## **Proposal for the [08] Series of amendments to Regulation No. 14 (Safety belt anchorages)**

### **I. Proposal**

## Addendum 13: Regulation No. 14

**Uniform provisions concerning the approval of vehicles with regard to safety-belt anchorages.** ~~ISOFIX anchorages systems and ISOFIX top tether anchorages~~

~~Figure 3  
Example for a modified Static force application device with support leg test probe (SFAD<sub>SL</sub>) showing the required adjustment range and dimensions of the support leg foot~~

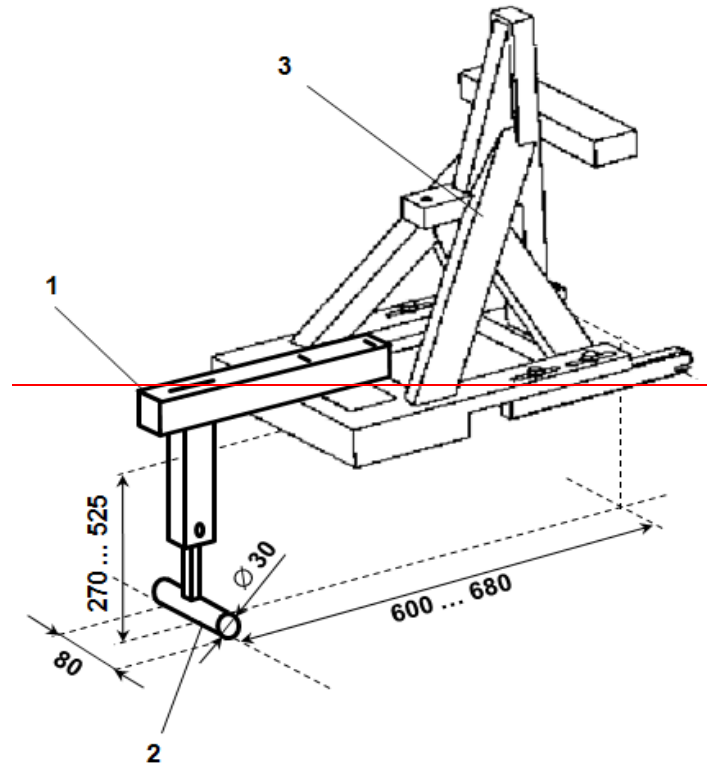
1. ~~Drawing not to scale.~~
2. ~~The support leg test device shall:~~
  - (a) ~~Ensure testing within the entire vehicle floor contact surface defined for individual i-Size seating positions;~~
  - (b) ~~Be rigidly fixed to the SFAD so that the forces applied to the SFAD will directly induce test forces into the vehicle floor, without reduction of the reactive test forces due to damping within or deformation of the support leg test device itself.~~
3. ~~The support leg foot shall consist of a cylinder, having a width of 80 mm, a diameter of 30 mm and on both side faces rounded edges with a 2.5mm radius.~~
4. ~~In case of incremental height adjustment, the distance between the steps for adjustment shall not be more than 20 mm.~~
